INDESIT company

Model type:
AD1600PXU

Commercial code:
F027163

1140180 Exploded views

Fig. n10402231

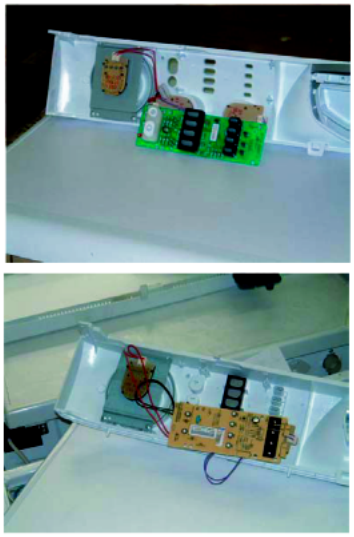
n1040231: Absent upper counter-weight

Our dishwashing machines have been designed with a static and dynamic balancing system to conform with the vibration, noise level, stability and reliability specifications.

In particular, the balancing has been obtained by the "balancing" mass, appropriately placed on the oscillating group. This balancing mass is made for:
Machines with spin cycle speed lower than 1400 rpm, by a frontal and an upper counter-weight in reinforced cement;

Machines with spin cycle speed equal or faster than 1400 rpm, by a frontal counter-weight in reinforced cement and by a cast iron universal joint spider (a red cross shaped component with 4 spokes, that in this range of washing machines fulfils both the structural and balancing functions);

FIG. 1

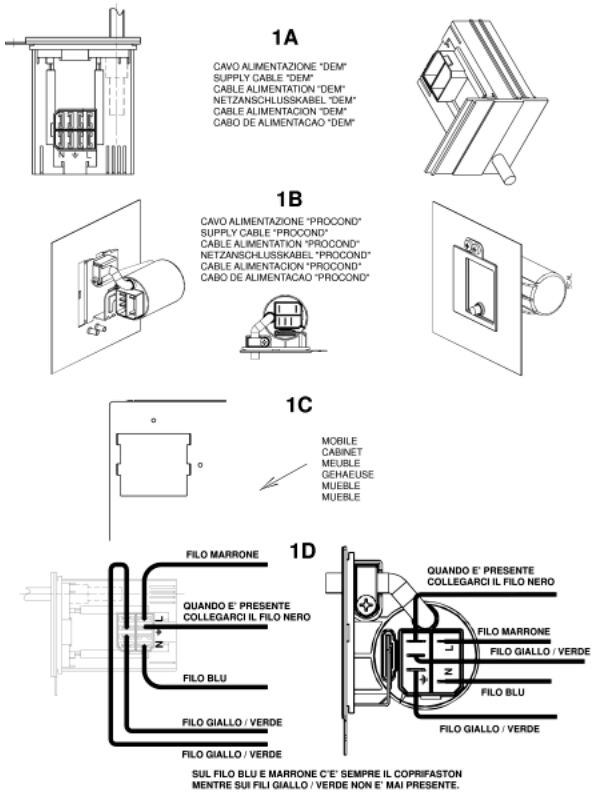
n1040282: New drainage OKO system.

From serial number 21219.0001, the new "OKO" drainage system has been introduced on the washing machines produced in the Comunanza factory.
The last two numbers of the Industrial Code (located on the rating plate) of the models relevant to this note will be 30 (e.g. 80233560130 - see Appendix A)

- EEPROM (the OKO system requires a new setting of load timing parameters). THE NEW EEPROMS REPLACE ALL THE ONES CODED PREVIOUSLY.
- BOWL (hopper tube hole shifted forwards);
- DETERGENT LOADING TUBE (see fig. 1);
- PRESSURE SWITCH (changed levels);
- OKO PUMP BOWL BLOWER + BALL (see fig. 2A, 2B and 2C);

- CONDUCTIVITY SENSOR (if provided, it is shorter than the premodification item);
- DRAIN PUMP (without detergent collecting tube connection);
- HOPPER (shifted in front of detergent loading tube connection). Fig. 3A post-modification. Fig. 3B premodification);
- AIR TRAP (different shape);
- PRESSURE SWITCH TUBE (different length);
- DRAIN TUBE STOP (specific);

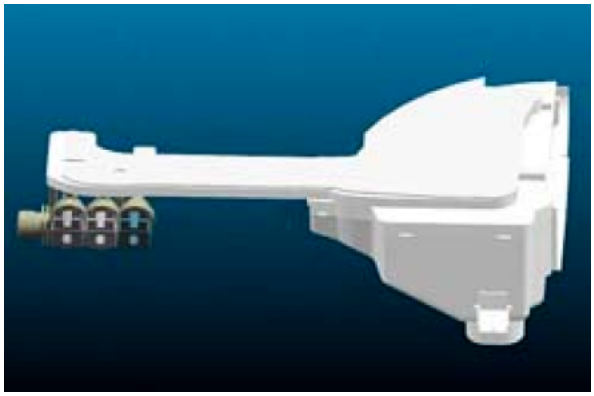
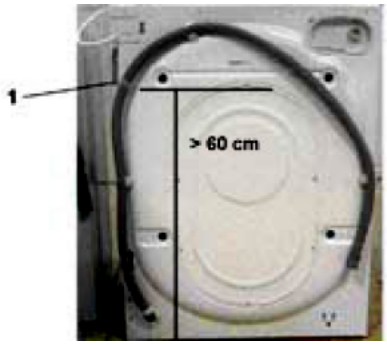
In particular, the OKO system consists of a spherical plastic component inserted in the tube that connects the bowl to the drain pump (see fig.2 A).
At the beginning of each wash cycle the washing machine fills water for 10 seconds and activates the drain pump for 2 seconds. In this way, the water level in the bowl is different from that in the drain tube; this difference increases the thrust of the ball upwards, closing the bowl-pump connection tube hermetically (see fig. 2D).
This system has the double advantage of:

1) separating the wash water and the water in the drain hose, thus saving energy during the heating phase;
2) and ensuring optimal use of all the detergent.
With the introduction of this new component, the detergent collecting tube is no longer required and the pump has one hole only to convey water from the tank.
For the correct operation of the OKO system, it is important that the drain hose of the washing machine remains fixed to the back of the unit with a plastic clamp (to this end, the clamp withstands a 25 kg load; see reference 1 in fig. 4); otherwise, the drain hose must absolutely reach the height of the clamp. (minimum 60 cm.)

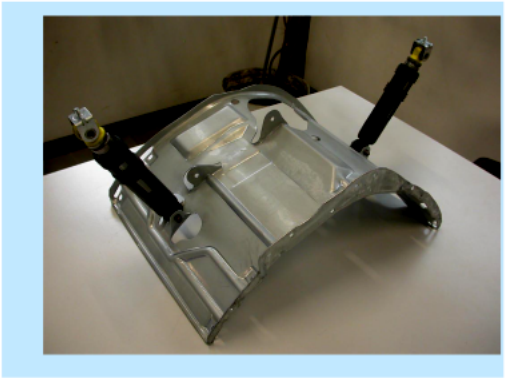
n1040325: New shock absorber fixing system with pin

From serial no. 40427.0001, shock absorbers have been fixed to the tank unit cradle with two 11 mm pins code C00110163 (see fig. 01 and 02 enclosed) in place of the 8 mm screws code 093750 and relevant locking nuts code 030443, on all washing machines and dryers produced in the Comunanza factory.
The items affected by this modification are:
1) The cradles have the same Service code, as they can be used in place of the new ones after widening the shock absorber fixing holes to a diameter of 10 mm.

Code 093848 - Tank unit cradle 46 lt
Code 093878 - Tank unit cradle 40 lt.
2) The new shock absorbers, with fixing bushing having no s/steel spacer, are not managed as they are interchangeable with the premodified items (make sure they are CIMA type, as the managed items), fixed with M8 screws code 093750 and related locking nut code 030443 (see figs. 05 and 06).
Code 093884 - Shock absorber 80 N
Code 093885 - Shock absorber 100 N

To remove the shock absorber from the tank, first extract the pin with a few hammer taps (see fig.03) until it is aligned with the tank bracket and then pull it out with a pair of pliers (see fig. 04).
(To refit the shock absorber use a new pin. Insert the pin until the toroidal edge is aligned with the bracket.)

Fig . 001

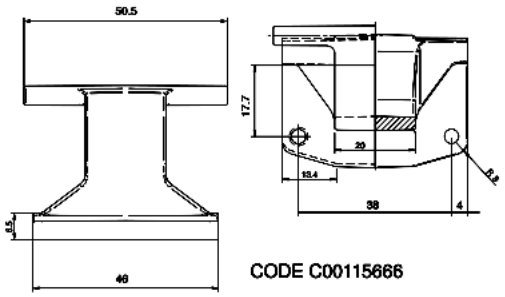
n1040349: Introduction of 150° Zamac hinge on Ariston 46 models.

From serial no. 50207.0001, all Ariston models produced in the Teverola factory (see table 001 attached) with industrial code (given on the rating plate) starting with 46, have been equipped with a Zamac hinge with 150° opening angle, code C00115666

(see Fig.001).
This modification has involved the introduction of the following items:

Code C00115670 - Complete door EVOII 150° white 27 with standard glass;
Code C00115674 - Complete door EVOII 150° white 27 with long glass;
Code C00115667 - EVOII body for 150° hinge white 27;

The premodified items are not interchangeable separately with the modified ones.
